BCA Assessment Report

Building 2A

Precinct 2 - Oakdale East Industrial Estate

SSDA-120888992

Figure 2 – Perimeter Vehicular Access Non-Compliances

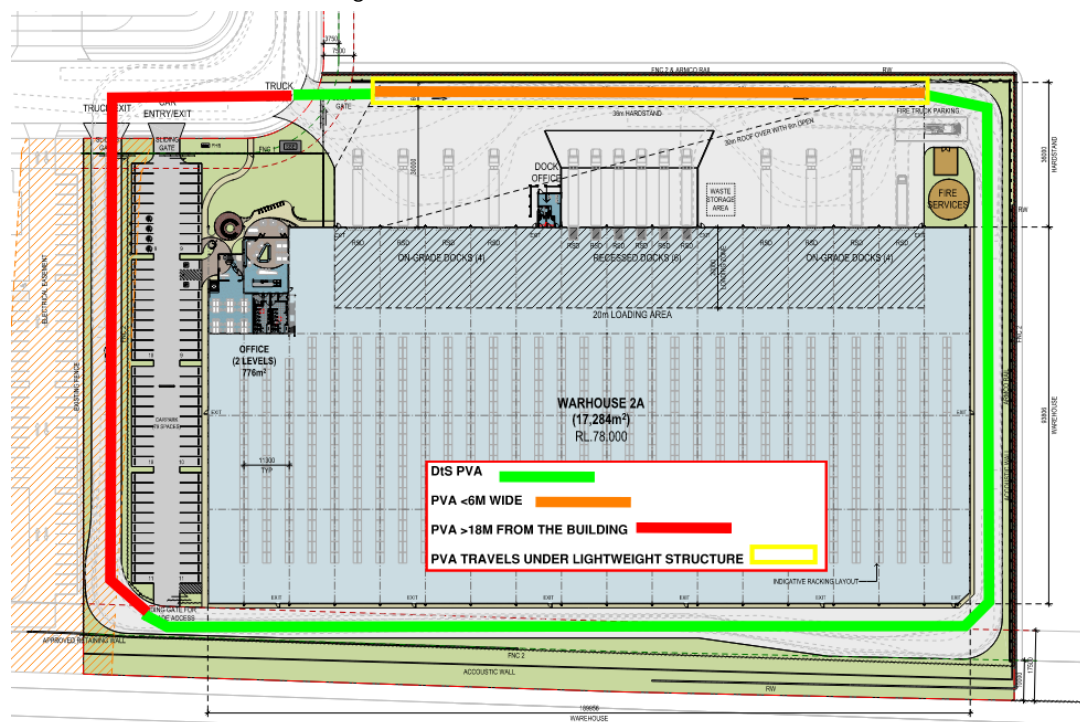
Comment: The building does not comply with the provisions of C3D5 and thus the following non-compliances are to be addressed as a Performance Solution by the fire engineer to demonstrate compliance with Performance Requirement CP9.

- + Perimeter Vehicular Access is less than 6m on the northern side of the building along the hardstand
- + Perimeter Vehicular Access is greater than 18m from the building along the western elevation of the site.
- + Perimeter Vehicular Access requires travel under the lightweight awning structure on the northern side of the building.
